## DSP-16057

Application	General Data	
<b>Project Name:</b> Powder Mill Road Consolidated Storage  <b>Location:</b> The north side of Powder Mill Road (MD 212), at the intersection with Cook Road and Powder Mill Road.  <b>Applicant/Address:</b> Arcland 1054 31 <sup>st</sup> Street, NW, Ste. 318 Washington D.C., 20007	Planning Board Hearing Date:	07/27/17
	Staff Report Date:	07/12/17
	Date Accepted:	05/19/17
	Planning Board Action Limit:	07/28/17
	Plan Acreage:	4.86
	Zone:	I-2
	Dwelling Units:	N/A
	Gross Floor Area:	152,269 sq. ft.
	Planning Area:	62
	Council District:	01
	Election District:	01
	Municipality:	N/A
200-Scale Base Map:	214NE06

SUBJECT: Detailed Site Plan DSP-16057  
Powder Mill Road Consolidated Storage

# LANDSCAPE PLAN

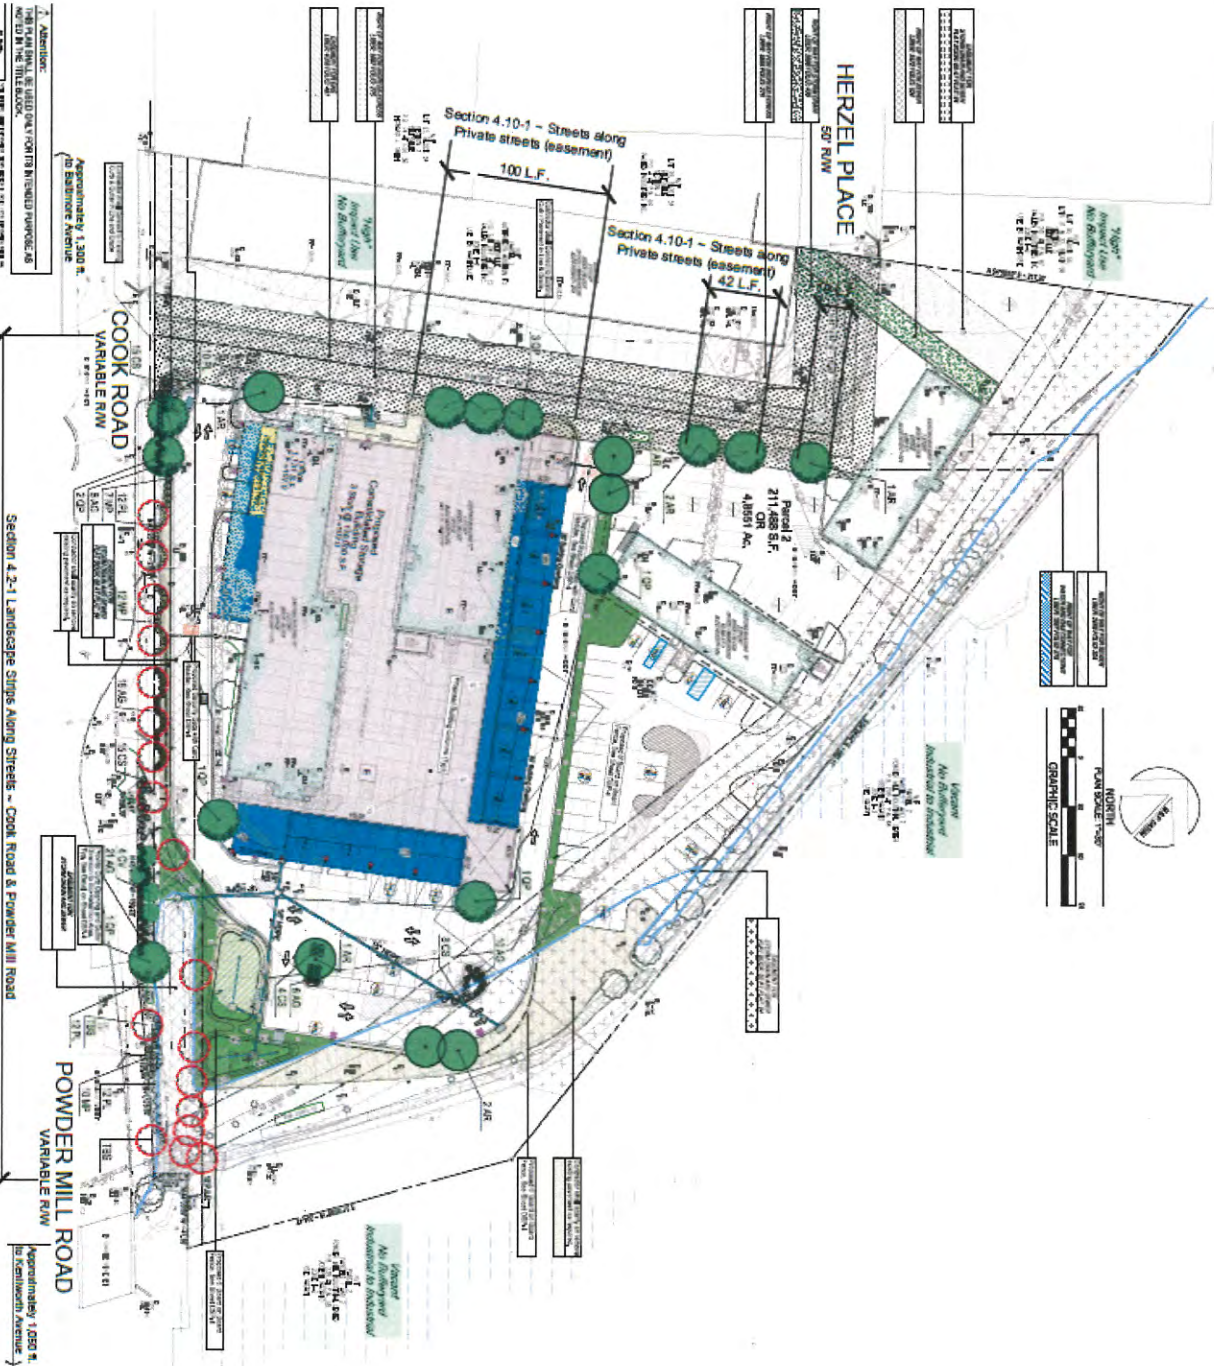
- a. **Section 4.2, Requirements for Landscape Strips Along Streets—**The site is subject to Section 4.2 along its western property line where it abuts Cook Road and Powder Mill Road. Section 4.2 requires a minimum 10-foot-wide landscape strip to be planted with a minimum of one shade tree and ten shrubs per every 35 linear feet of road frontage in the Developing Tier. The road frontage along these roads is approximately 520 feet,

however, the plans do not provide a label showing the dimension of road frontage and should be updated prior to the certification. A condition has been included in the Recommendation section of this report to provide the length of the 4.2 buffer on the landscape plans. The length of this landscape strip requires that 15 shade trees and 149 shrubs be provided. This application meets this requirement and proposes 23 shade trees, 4 ornamental/evergreen trees, and 152 shrubs.

- b. **Section 4.3, Parking Lot Requirements**—The site is subject to Section 4.3 of the Landscape Manual, specifically Section 4.3(c)(1) and 4.3(c)(2). Section 4.3(c)(1) of the Landscape Manual, requires parking lots within 30 feet of the property line in the developing tier provide a five-foot-wide landscape strip between the parking lot and any adjacent property line, and should be planted with one tree and three shrubs for every 35 linear feet of parking lot. This application includes 135 feet of frontage along the parking lot of the office buildings with the adjacent parcel and should be revised to provide a five-foot landscape strip, planted with three trees and 11 shrubs between the existing parking lot and Parcel 2. The plans incorrectly show conformance with Section 4.10 in this area, which provides regulations for private streets and should be revised. A condition has been added to the Recommendation section of this report to update the plan and schedule, to provide conformance with the appropriate section of the Landscape Manual, because this is not a private road.

Section 4.3(c)(2) of the Landscape Manual, stipulates that interior parking lot planting is required for parking areas that measure 7,000 square feet or larger. The application proposes a parking area of 33,175 square feet and is required to provide an interior landscape area of eight percent or 2,654 square feet. The application meets this requirement and proposes to include more internal planting area than required.

1. Need to add a note with in the Landscape Schedule for Section 4.2-1 along Cook Road and Powder Mill Road that there is overhead wiring along the street to clarify the allowed substitution of plant materials.
2. No sign details submitted for review.

- e. Provide a valid standard letter of exemption from the Woodland and Wildlife Habitat Conservation Ordinance for this property.
  - f. Provide dimensions showing the length of the 4.2 buffer on the landscape plans.

- h. Show conformance with Section 4.3 of the Landscape Manual and update the landscape schedules.
2. Prior to the issuance of the building permit, the applicant shall either provide a drive-isle transition, which merges into the one-way traffic pattern from the two-way drive isle at the entrance of the consolidated storage facility on the southeast die of the building, or record a share-access easement in the Prince George's County Land Records based on the existing easement, if it is necessary. If the later occurs, the drive-isle transition shall not be required and void.

# BUILDING ELEVATIONS

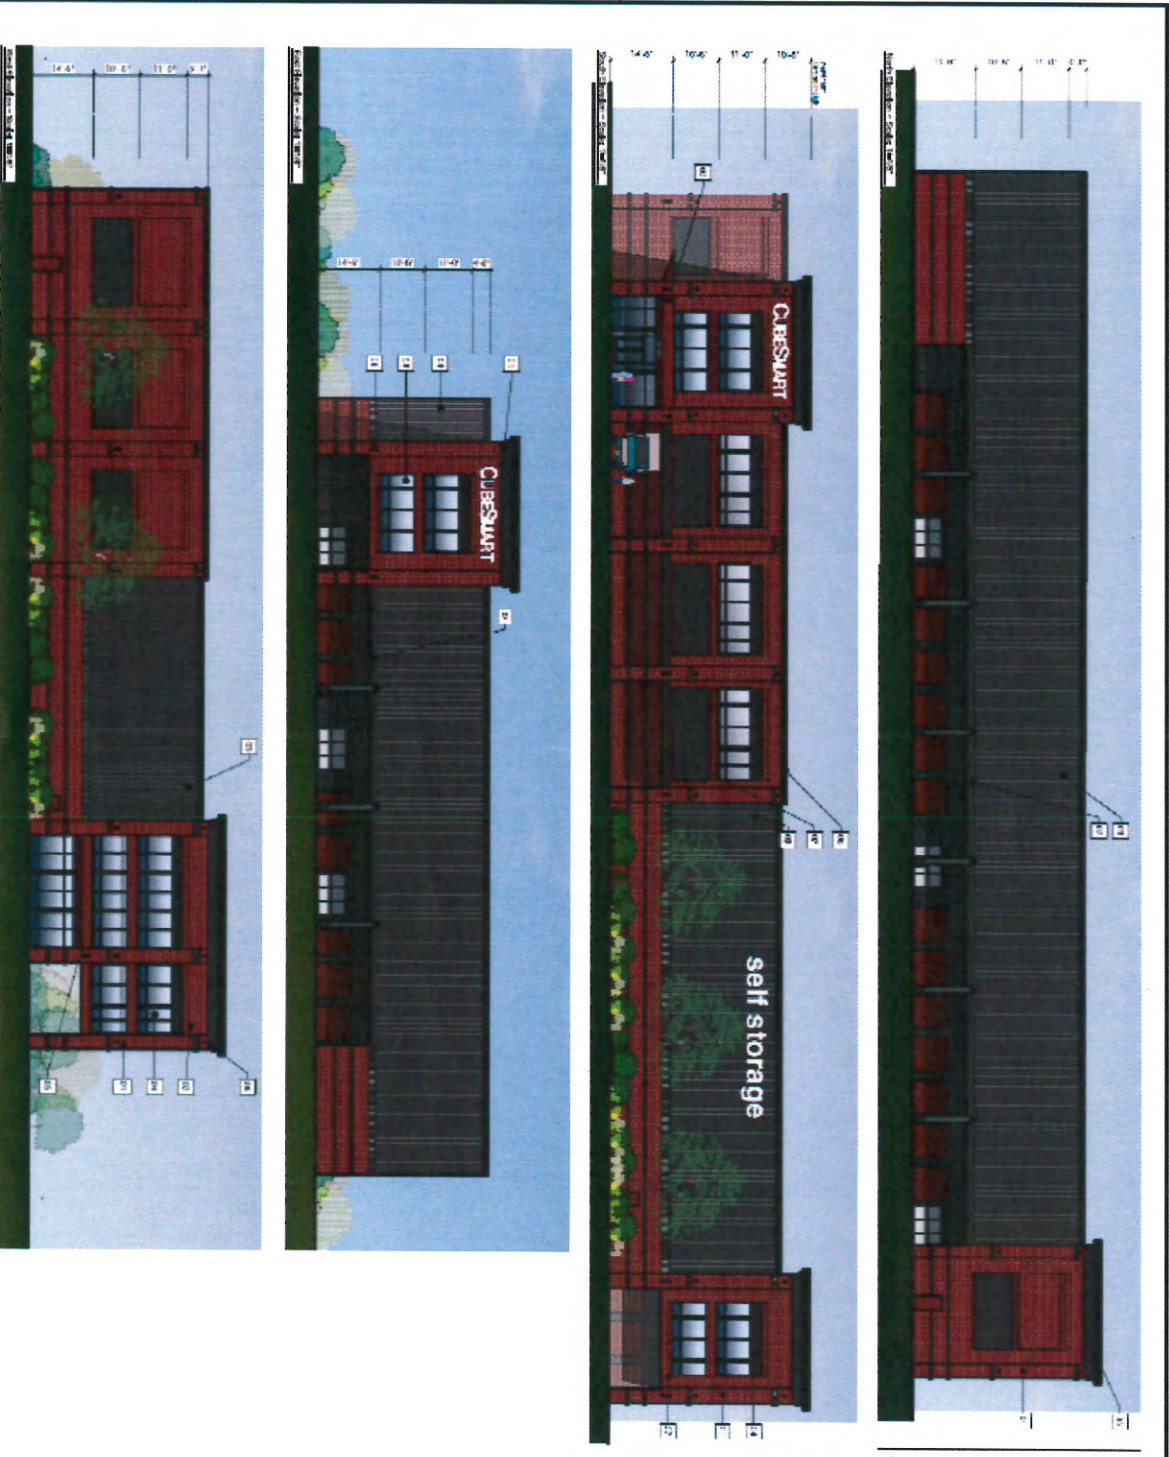
**Signage:** Two building-mounted signs are located on the south and east elevations and one freestanding sign is being proposed with this application. A detail for a freestanding pylon sign is provided with the plan set that advertises the name of the storage facility. The sign is proposed to be internally illuminated with a height of 27 feet. It has been designed in a similar color scheme as the buildings and reflects the tenants name and logo on the sign. The sign includes a signage face of approximately 192 square feet. However, staff notes that the location of this sign has not been provided on the site or landscape plans, and its location should be shown prior to certification of the plans. A condition has been added to the Recommendation section of this report, to require the applicant to show the location of this freestanding sign.

Two building-mounted signs are located on the south and east elevations which advertise the use of the facility. Each of these signs show a proposed sign area of 63 square feet. The following table includes the sign type, height, and area of the freestanding and building mounted signs proposed with this application:

**Comment:** The architectural elevations and site plan have been designed so that they do not show entrances to the individual storage units from the street or from adjoining land in a residential or commercial zone. The exterior entrances to the storage units are being proposed on the north and east sides of the building. It should be noted that these sides of the building face I-2 zoned property.

**Comment:** The proposed building has been designed to incorporate a number of building materials into the design of the building to create visual interest, and included materials such as brick, metal panels, masonry accents as well as decorative cornice along the top of the building. In addition, the building creates visual interest by varying the depth of the building, especially along the frontage of Powder Mill Road. The varied depth not only creates visual interest but provides a functional value because it creates a covered parking area for customers.

1. Prior to certificate approval of the detailed site plan, the applicant shall revise the Detailed Site Plan to:
  - a. Show the location of this freestanding sign, or remove the detail from the plan.

- b. Change the height of the freestanding-pylon sign to the maximum allowable height of the 25 feet and reduce the signage area for this sign to reflect the allowed sign area.

- c. Provide details for the two additional signs shown on the building's south and east elevations, which advertise the tenant's name, and update the sign calculation schedule to reflect their additional signage area.
